Product Change Notice (PCN)

PCN Number: **PCN-0451069R-01**

Product(s) Affected: PJ-018H-SMT-TR

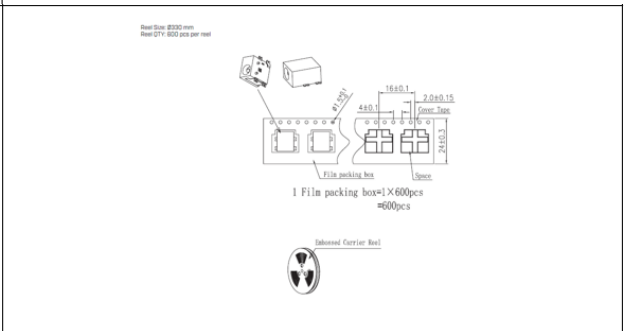
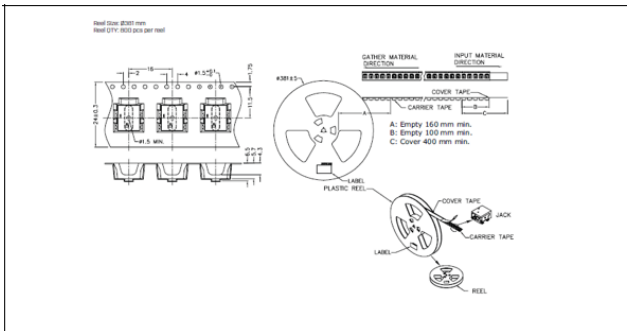
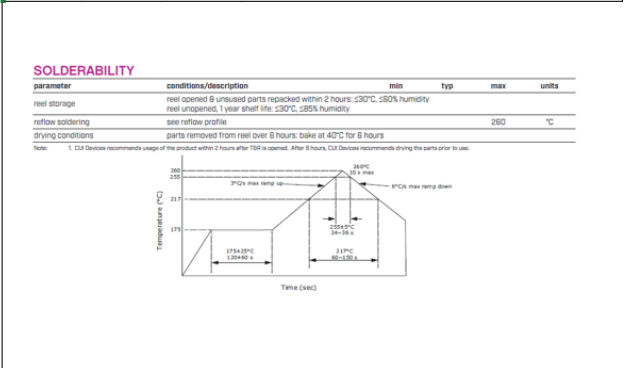
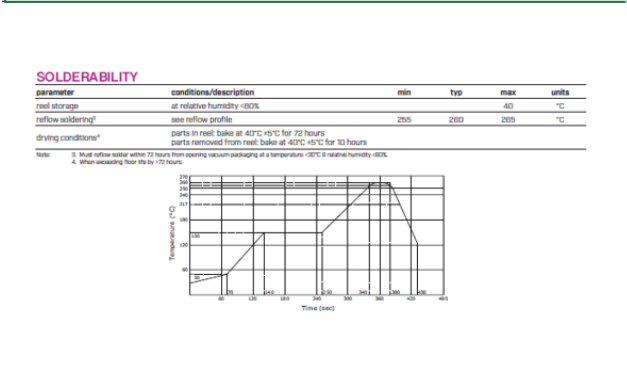
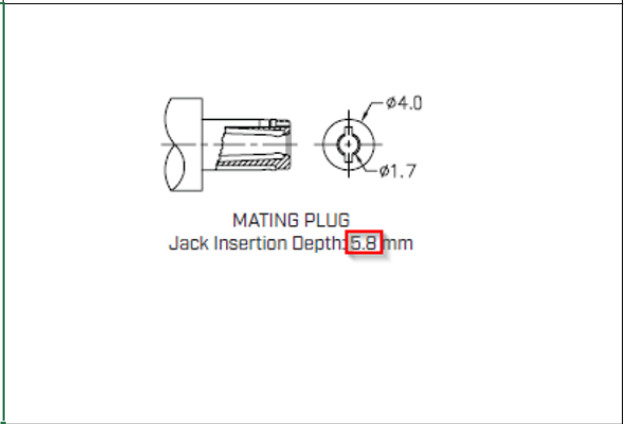
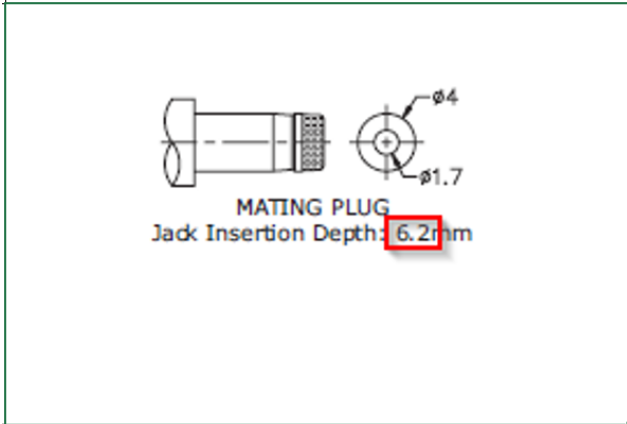
Description of Change: mechanical, material, packaging, and soldering differences as shown below:

MATERIAL	PLATING
center pin	copper	nickel
terminal 1	brass	silver
terminal 2	copper alloy	silver
terminal 3	brass	silver
plastic	PA6T or equivalent

DESCRIPTION	MATERIAL	PLATING/COLOR
center pin	H62	silver
terminal 1	brass t=0.30	silver
terminal 2	C5210R-EH t=0.20	silver
terminal 3	brass t=0.25	silver
housing	PA9T (UL94V-0)	black
